DRV18-00493
ATTACHMENT 2

ROSE HILL MIXED-USE | DRC CONSOLIDATED PACKAGE | APRIL 24, 2019

CONCEPTUAL DESIGN CONFERENCE SUMMARY & COMMENTS

CONCEPTUAL DESIGN CONFERENCE CONCEPTS

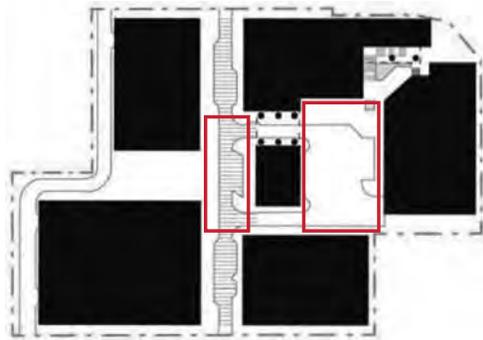
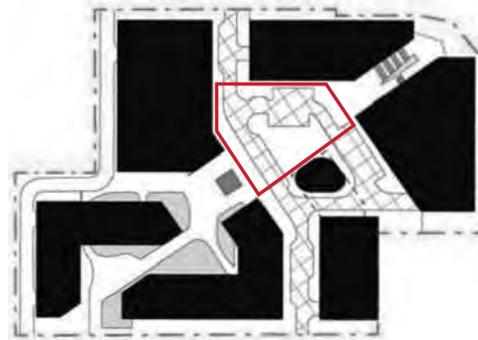
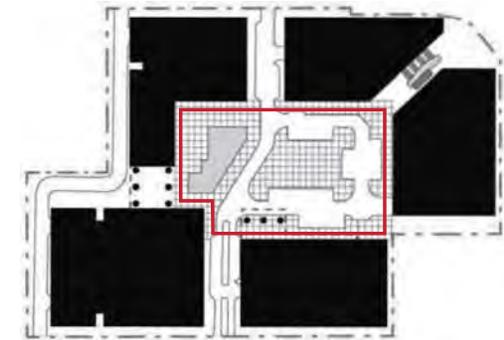
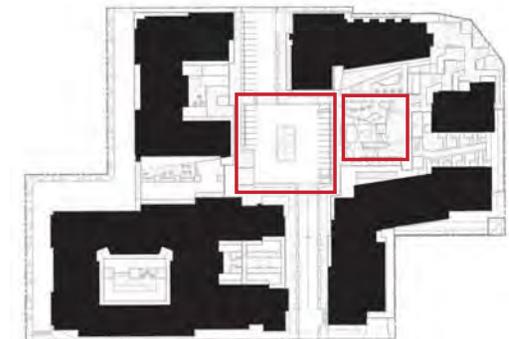
In general, the board appreciated the overall massing of the buildings.
They would like to see further development of the north side and facade along 85th.
They also encourage further development of the hub scheme design.
The size of the hub scheme's open space seemed about right.

1 - DRB: Concern for the north facade and the height of the structure when viewed from the neighborhood to the north.	RESPONSE: The massing along the north side of the project has been carefully considered to no impose upon the adjacent properties. The building facades have been held back from the north property line approximate 45' to provide perimeter auto and pedestrian circulation and landscape buffering which minimizes the impact of the proposed buildings via landscaping and distance. In addition, the north building facades of building A and B have upper level step-backs, are broken into two separate buildings and provide generous modulation.
2 - DRB: Thinks the interior could be simplified with a diagonal piazza or simpler shape at the interior.	RESPONSE: Previous DRB deliberations favored the size of the Hub Scheme while preferring the well defined, strong form of the Piazza Scheme. Our proposed plaza configuration is a well-defined rectangular space that has been divided into distinctive automobile and pedestrian plazas. The space is well organized and easily comprehended which aids in clear circulation with a central focus.

3- DRB: Food services from the grocery store could engage 85th, ensure activation happens along 85th.	RESPONSE: Activation of the SE corner terraces and entrance stairs is very important to the success of the pedestrian access to the intersection. The grocery mezzanine will likely include a food service dining area, is positioned to spill out onto one of these mid-level terraces. The 85th street frontage will be well engaged via a continuous clerestory storefront which looks down into the grocery store. The east end of this frontage will provide a commercial space and a residential entrance/ lobby which is well-connected to the SE corner plaza.
4 - DRB: The abruptness of the approach to U-Haul, may also be an issue. We want to make sure that we don't end up with a very abrupt wall here, which is along 85th.	RESPONSE: Any previous abruptness between the building mass along 85th st. Relative to the U-Haul site, has been mediated by bifurcating our south facade into two buildings. In addition, the west elevation adjacent to u-haul of our residential massing has been held back from the property line and broken into two distinct building masses. This variation in facade design and orientation helps provide visual interest adjacent to the U-Haul Property.

5- DRB: Would like to see how the long walls will be modulated and/or broken up along 120th and 122nd.	RESPONSE: The previous scheme's long walls along the east and west elevations have been broken into more equal lengths, as well as been well modulated into distinctive facade types.
6- DRB: How will pedestrians like kids travel through the site? It's clear that the east is friendlier then west.	RESPONSE: Pedestrians well access and travel through the site via well defined access points. The southeast corner plaza will invite the visitors with a generous and well organized sequence of terraces connected via a grand stair. Entrance drives with generous sidewalks and landscaping will connect both 120th and 122nd Street's to the interior plaza. The need for any exterior circulation between the northwest in northeast side corners isn't relevant to off-site or on site circulation.
7 - DRB: The dilemma is that the project faces inward. I'm going to encourage the applicant to also face outward along 120th & 85th, in the same way that happens along 122nd.	RESPONSE: The previous scheme fronted parking garages along both 120th and 122nd. This exposed parking garage layout has been eliminated. The 122nd street elevation now provides street level commercial to residential entrance lobby's, with some residential units buffered by landscaping. The 120th street elevation now provides street level health club storefronts and residential entrances. Both 120th and 1202nd now provide pedestrian oriented frontages which provide an interesting and active walk and experience.

8 - DRB: I'm not sure that the Costco is a destination, or that the pedestrian pathway needs to extend all the way to the north. Signalization will be required at some point in the future.	RESPONSE: The existing pedestrian crosswalk will likely need to be relocated to provide direct access from the Costco store to the remaining Costco parking opposite 120th st. Whether signalization is necessary is yet to be determined.
9 - DRB: Residential uses at the ground floor should be encouraged along the sidewalks at both 120th & 122nd. Would like to see ground floor connections with section or elevations.	RESPONSE: Please see previous response regarding project facing outwards towards 120th and 122nd streets.
10 - DRB: Would like to see some of the clarity of the strong interior piazza form brought into the hub scheme, through the use of paving, landscape material, and edges of buildings.	RESPONSE: The strength of the previous interior piazza scheme was in the clarity of it's geometric space. Unfortunately, the development of the parking and pedestrian areas appeared very suburban and reminiscent of the strip retail center. Comparatively, we have reduce the size of the plaza, defined distinctive automobile versus pedestrian areas, and suggest clearly defined circulation patterns and casual seating areas, separated by generous landscaping. Please see the illustrated site plan.

11 - DRB: Definition of the outdoor room configuration is important. Sun exposure is important to preserve along the north edge of the grocery store, and the massing of the housing above.	RESPONSE: The central plaza is well defined by the adjacent commercial spaces, with the pedestrian implies a space appropriately scaled to appear well utilized and active. The upper residential facades are stepped back from the commercial massing to provide a secondary upper plaza scale which affords generous sunlight. The upper residential mass along 85th ST is divided to provide excellent midday sun exposure. The pedestrian plaza as well as the north grocery frontage will be an excellent outdoor experience.
